**From:** [John Ellis](#)  
**To:** [Cates, David](#)  
**Cc:** [Kalman, Kenneth](#); [Downs, Brittany R.](#)  
**Subject:** [External\_Sender] Re: Questions about raffinate disposal  
**Date:** Wednesday, September 09, 2015 5:03:24 PM  
**Attachments:** [SFC responses to questions from David Cates.docx](#)  
[FIGURE A R5.pdf](#)

SFC responses to questions from David Cates – ODEQ

PROJECT: SEQUOYAH SITE DISPOSAL CELL  
TITLE: PROPOSED MATERIAL CELL LOCATION

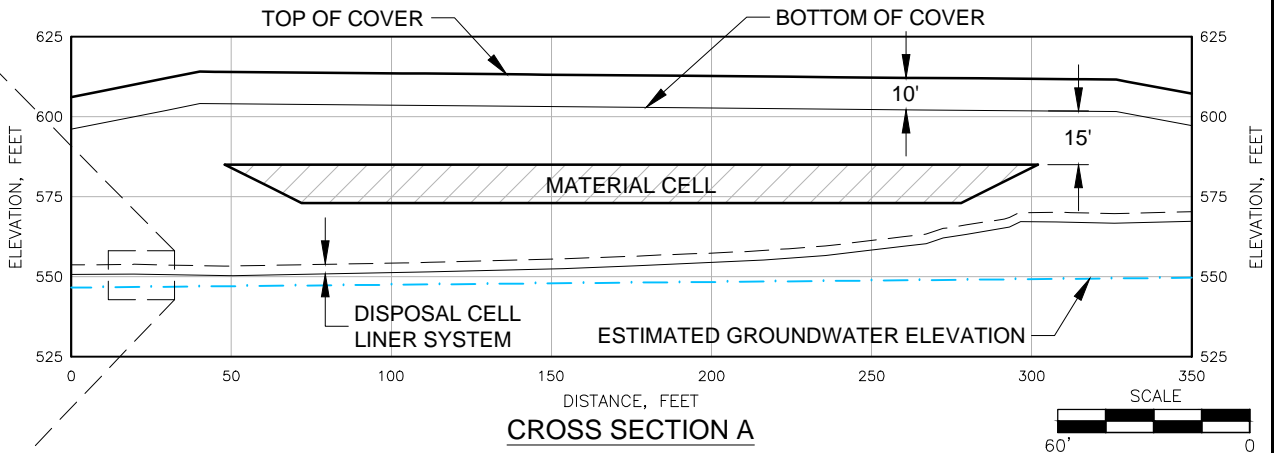
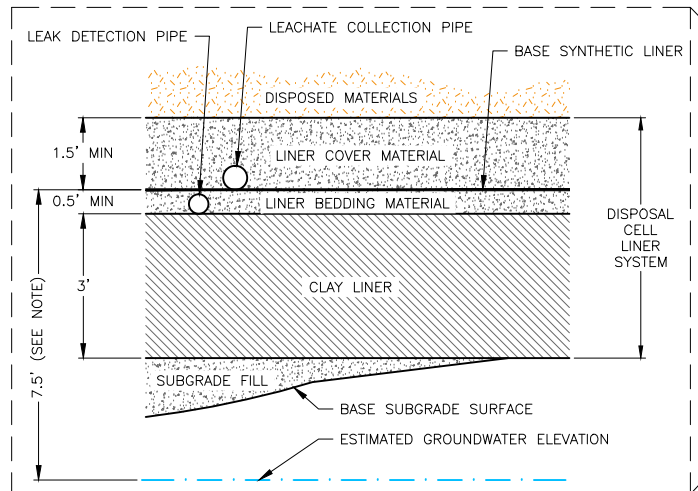
4. Where will the sacks be placed within the cell? Distance to bottom liner? Distance to top of cover?

The sacks will be placed in the north central part of the Phase III portion of the cell. Distance to the bottom HDPE liner will vary from x feet to y feet (the bottom of the Phase III cell base is sloped to the west to assure drainage of leachate to the collection point. The distance from the top of the raffinate bags to the top of the cell cover will be a minimum of 23 feet, which is the thickness analyzed in the Reclamation Plan. The attached drawing (Figure A R5) depicts the approximate location of the raffinate bags, both in plan and elevation views.
